Access Compliance Report

Public Rights-of-Way

Intersection ID: N/A	Main Street: OLD_PINEVILLE_RD	Cross Street: N/A	Location: SE
ADA ID: AFE47A9C5001	Ramp Type: Perp	Initial Pass/Fail: Pass	Overall Compliance: No
Codes/Mitigation Info/Possible Solution		Field Measurements/Component Compliance	
Severity Score: 2.5

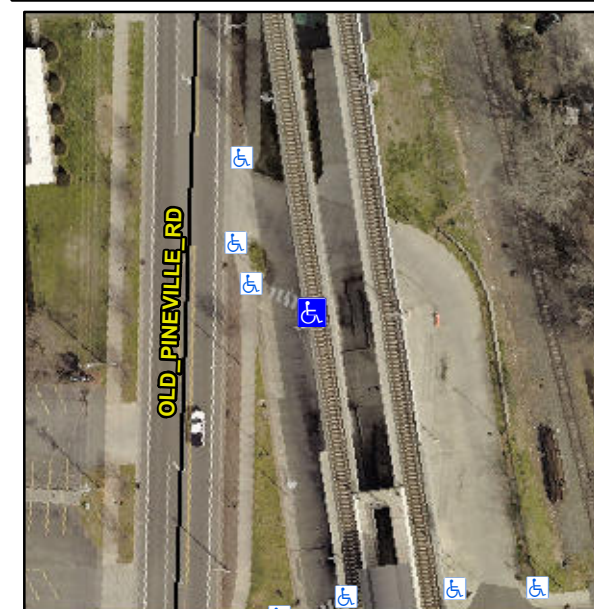
Remove & Replace Detectable Warning System.

R305.1.4
